# Access Compliance Report Public Rights-of-Way (Curb Ramps)

Main Street: N/A Cross Street: OAKVALE\_DR Location: NE

ADA ID: RPAT210923121352 Ramp Type: Type 1 - Perpendicular Diagonal Initial Pass/Fail: Fail Overall Compliance: No Severity Score: 30

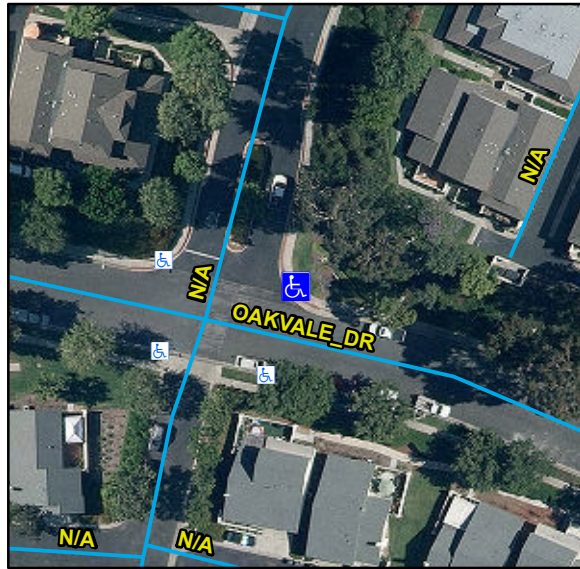
| Compliance | Description                           | Data | Compliance | Description                   | Data |
|------------|---------------------------------------|------|------------|-------------------------------|------|
| No         | Ramp Run Slope (%)                    | 14.6 | N/A        | Flare Slope LT (%)            | N/A  |

Remove & Replace Curb Ramp With Two New Directional Ramps or Equivalent.

R204.3, R304.2.2, STD 1115
